## **SSD 8544 - Glebe Island Aggregate Handling Facility and Concrete Batching Plant**

### **The Proposed Amendment**

The proposed amendment to the development application would be limited to replacing the Site Plan Drawing (GAs – D1, Revision C, dated 30/10/2019) with the attached Site Plan. The figure below provides a comparative illustration of the design of the facility as it is proposed to be amended, with the red line boundary showing the location of the buildings and structures based on the current plan, for comparative purposes. The proposed amendments are described as follows:

### Proposed Hanson Aggregate Facility & Concrete Batching Plant

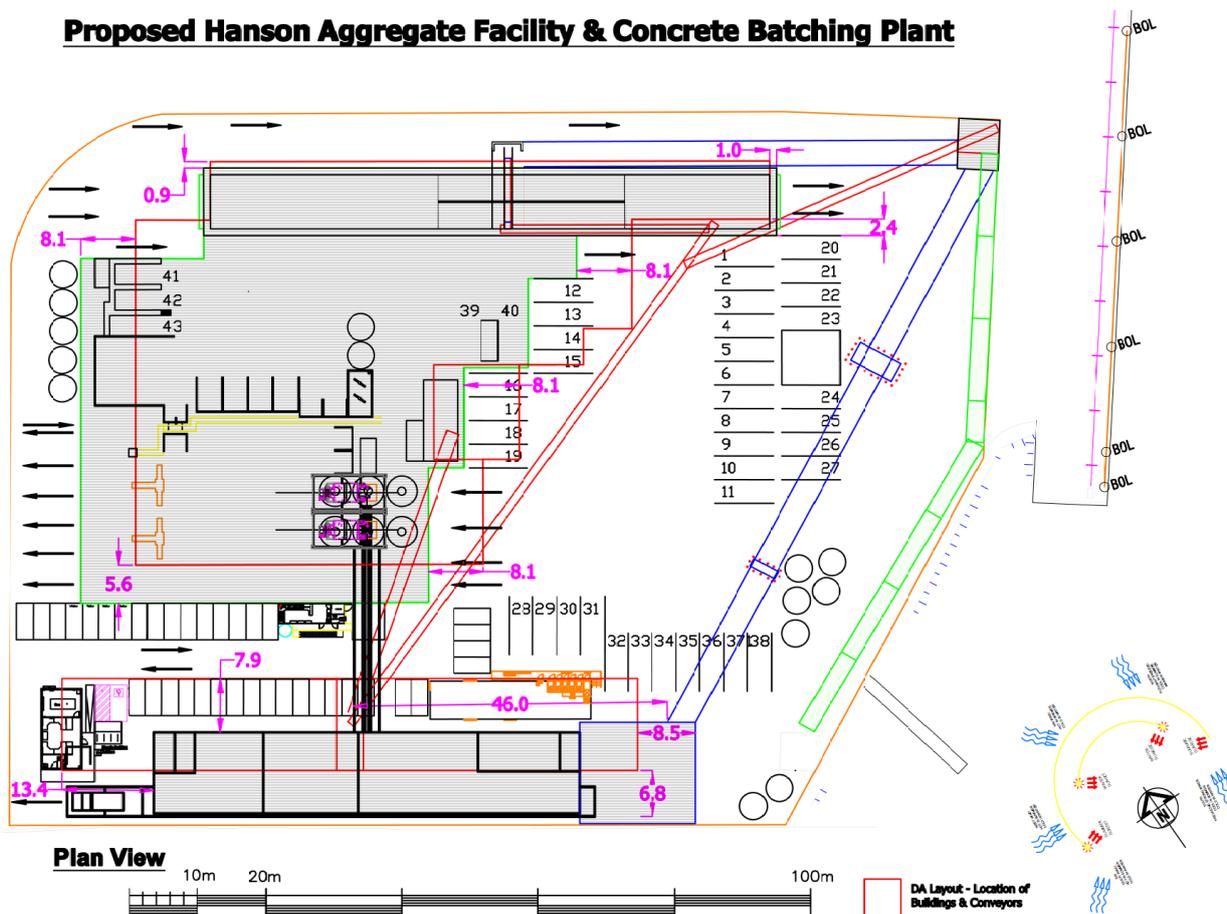
- Shifting the concrete batching plant shed approximately 8m towards the west, away from the closest residential receptors in Pyrmont.
- Shifting the aggregate silos approximately 7m to the south, and a minor reduction in the overall footprint of the aggregate storage silos.

- Minor rearrangement of light vehicle car parking to accommodate the revised building footprint. No change in total number of light vehicle parking spaces.

- Minor rearrangement of truck parking spaces to accommodate the revised building footprint. Total number of truck parking spaces would reduce from 50 to 43.

- Minor relocation and reorientation of enclosed receival bin conveyor, to create a shorter overall length of the conveyor between the aggregate receival bin and the aggregate storage silo.

- Relocation of the site office and reception building to the western end of the aggregate storage silos, compared to the western end of the concrete batching plant shed.

- Relocation of the site water tanks to accommodate the revised building footprint.
